MINERALS PROGRAM INSPECTION REPORT
PHONE: (303) 866-3567

MINE NAME: Upland Gravel Pit No. 3	MINE/PROSPECTING ID#: M-2005-077	MINERAL: Sand and gravel	COUNTY: Mesa
INSPECTION TYPE: Monitoring	WEATHER: Clear	INSP. DATE: July 5, 2023	INSP. TIME: 12:30
OPERATOR: Upland Gravel, LLC	OPERATOR REPRESENTATIVE: Jason Rinderle	TYPE OF OPERATION: 112c - Construction Regular Operation	
REASON FOR INSPECTION: Normal I&E Program	BOND CALCULATION TYPE:	BOND AMOUNT: \$57,785.00	
DATE OF COMPLAINT: NA	POST INSP. CONTACTS: DRMS	JOINT INSP. AGENCY: U.S.BLM	
INSPECTOR(S): Amy Yeldell	INSPECTOR'S SIGNATURE: 	SIGNATURE DATE: July 17, 2023

Photo 2: Phase one overview, NW highwall

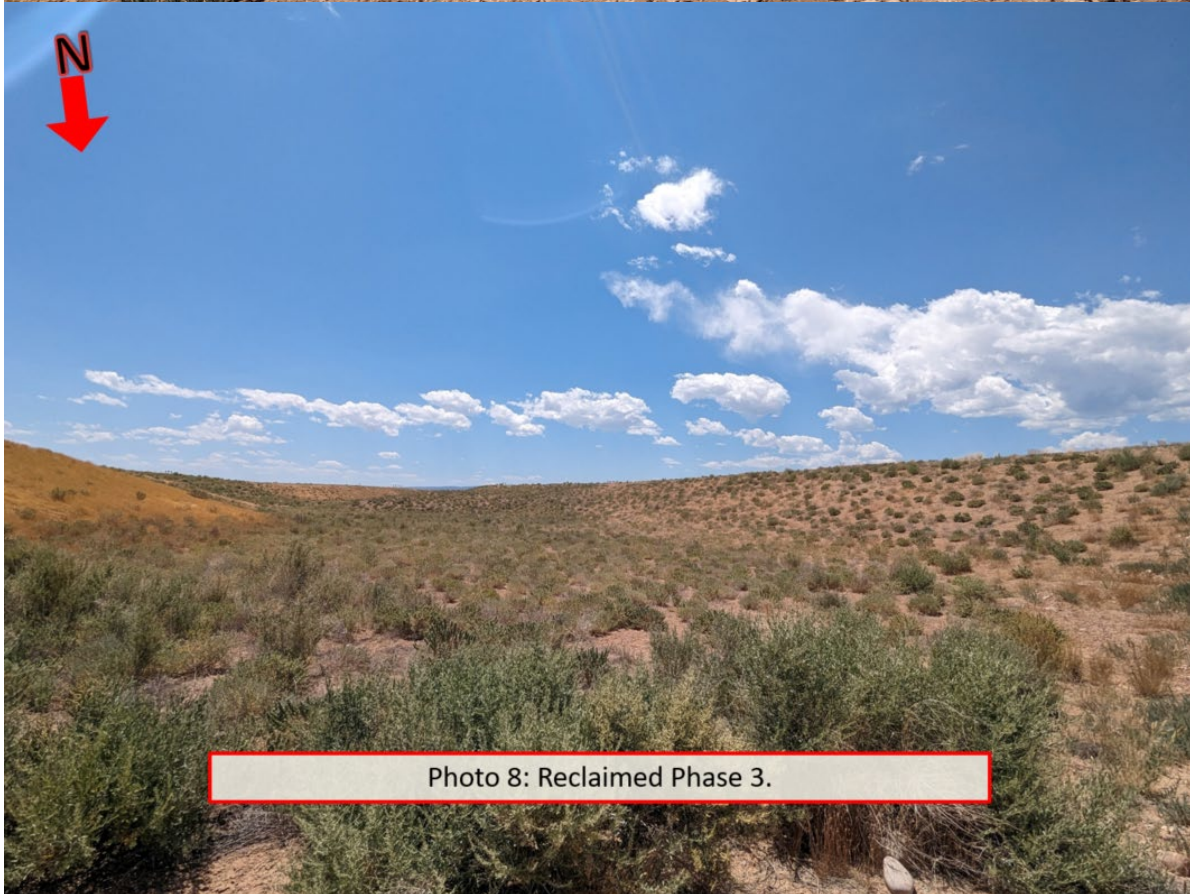
Phase 1, 2 and 4 are generally mined out with a flat pit floor remaining. The northwest highwall of Phase 1 and 2 adjacent to phase 9 is near vertical and 15 feet high by approximately 500 linear feet. Slope may be cut/fill. Overburden is stored above the highwall along Phase 9 (Photo Two). All other overburden is stored on the pit floor on the south side of Phase 2. The Northeast sloped of phase 1 and 2 are generally slopes at a 3H: 1V with only minor grading left to achieve final contour and smooth out adjacent stockpiles (Photo Three). The north edge of phase 1 near the road will need to be pulled back to blend naturally, approximately 300 LF at a 1H: 1V, 15 feet high.
